AMELIA LAKE SUBDIVISION, **PHASES 1-2**

Revised for the October 2nd meeting:

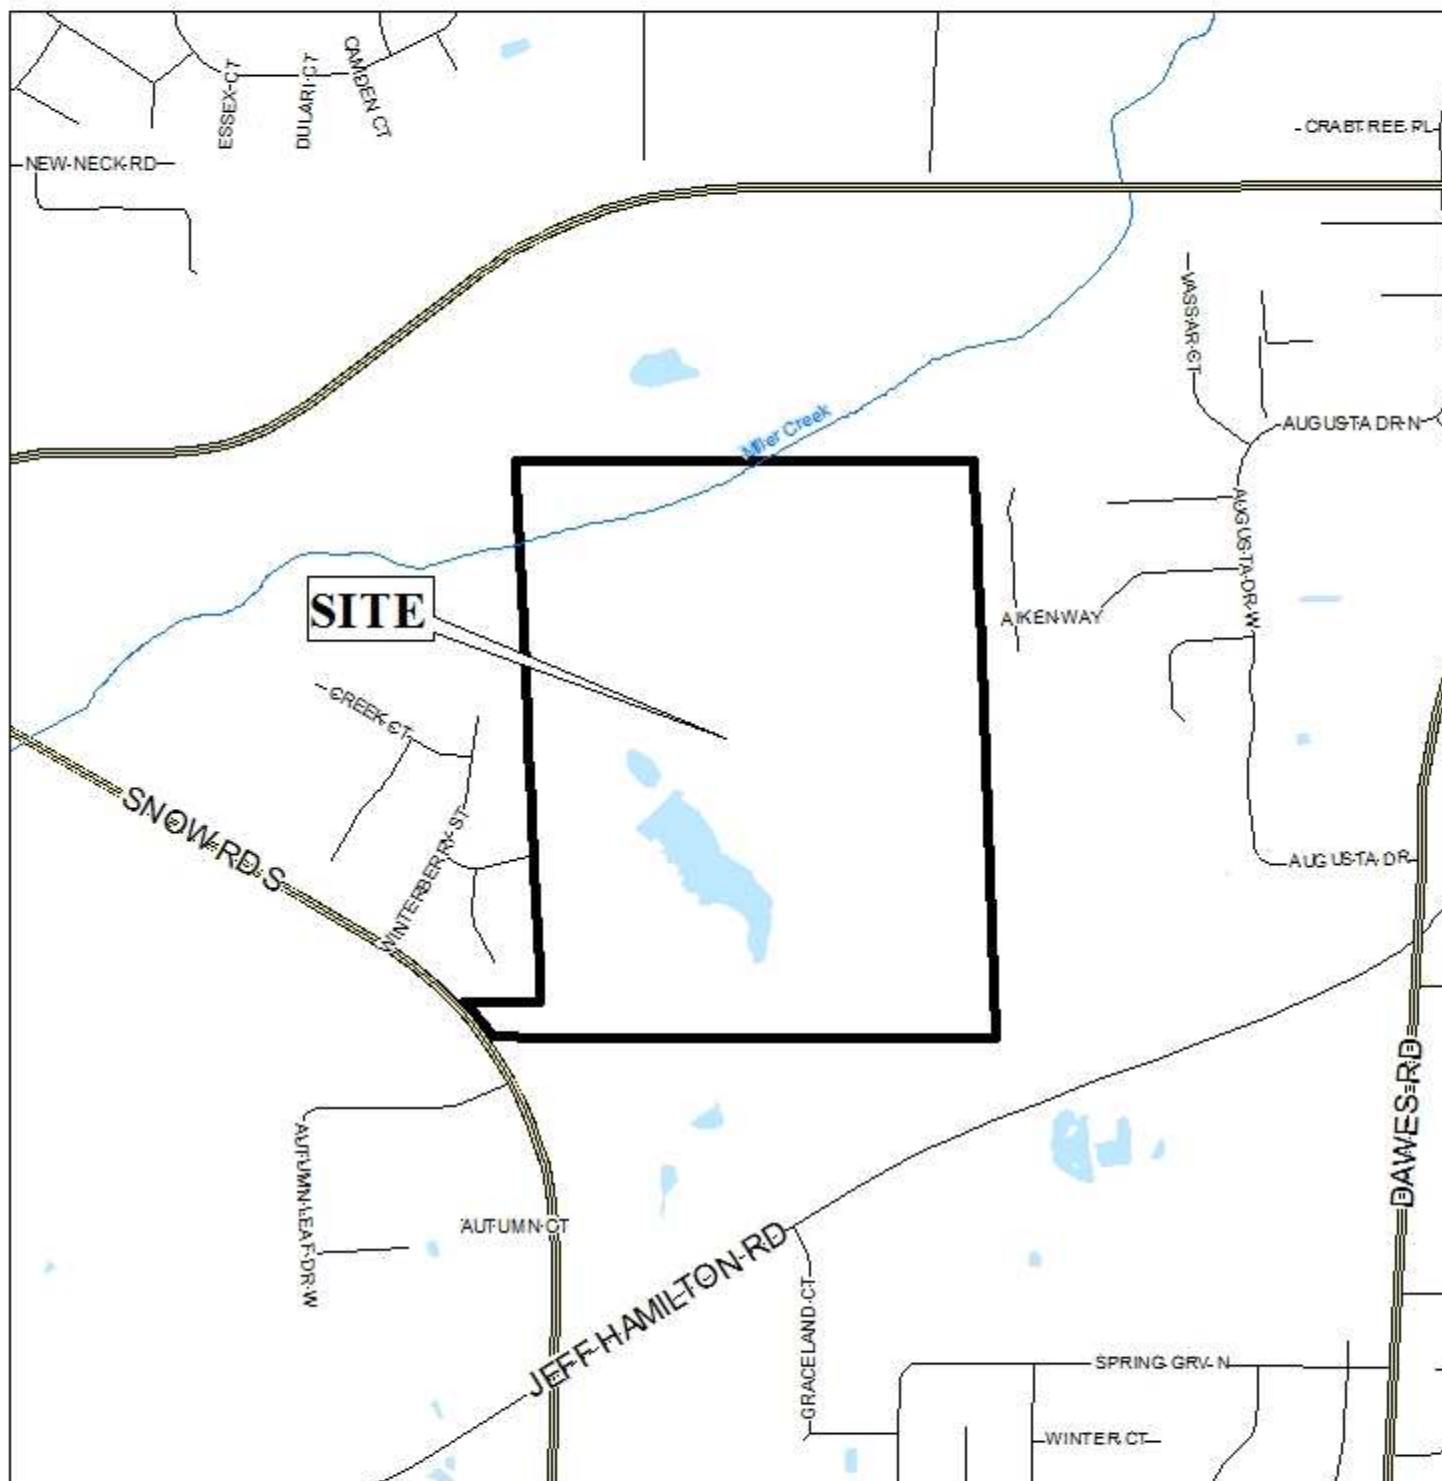
*It appears that Redberry Drive is a **public** street and any decision to not continue this street, as proposed, should not be based on an economic standpoint. Community input is vital to any public hearing process; however, in this instance, it is up to the Commission to ensure that public's general welfare is not compromised or hindered in anyway.*

*If the Commission were to waive Section V.B.1. for this request and require turnarounds instead, as proposed, Amelia Lake Subdivision would have **only** 1 access point to serve over 40 lots, plus potential future development, which could prove to be hazardous and impede safety.*

DETAIL SITE PLAN

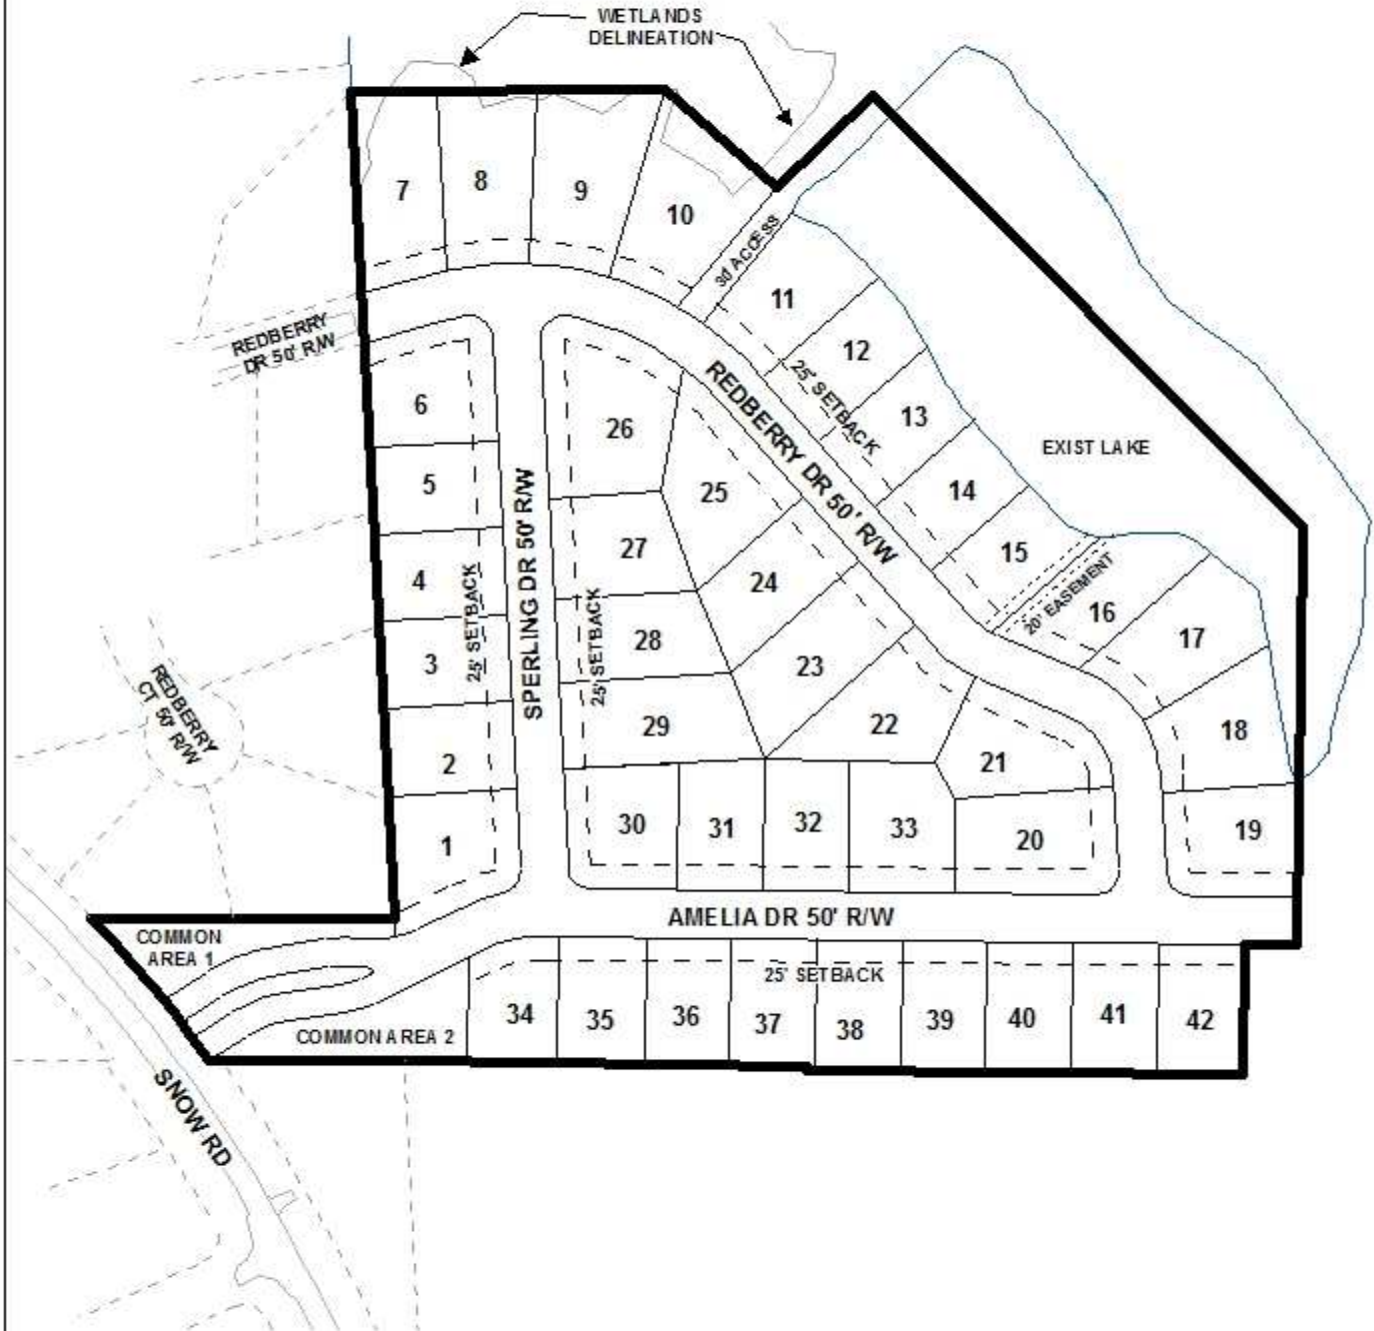
The application was heldover from the September 18th meeting at the applicant's request. According to the revised information submitted, it appears the applicant now desires a one-phase development, instead of the original two, and has reduced the total number of lots from 48 to 43. It appears the proposed Lot 43 may be developed at a later point; however, the applicant stated there were no development plans at this time. The revised plat also depicts an increase in

the lot width from 80' to 90' for the proposed Lots 1-42; however, it appears that none of the alterations to the site have altered the road layout in any way, as originally proposed.

Staff cannot overlook the fact that there has been significant neighborhood opposition from the residents within the existing Holley Branch Subdivision over the continuation of the existing Redberry Drive, which is considered a street stub and proposed to be extended within the proposed Amelia Lake Subdivision. Section V.B.1. of the Subdivision Regulations, requires connectivity between subdivisions and all street stubs be extended.

- 1) Provision of a connection to Redberry Drive, as required by Section V.B.1. of the Subdivision Regulations;*
- 2) Revision of the Final Plat to depict dedication along Snow Road, to Mobile County, sufficient to provide 50' as measured from centerline;*
- 3) Revision of the lot size information and 25' minimum building setback line on the Final Plat to reflect dedication;*
- 4) Placement of a note on the Final Plat stating no future subdivision of Lot 43 until the existing driveway is paved and improved as a street to Mobile County Engineering Standards;*
- 5) Placement of a note on the Final Plat stating that all common and detention areas shall be maintained by the property owners;*
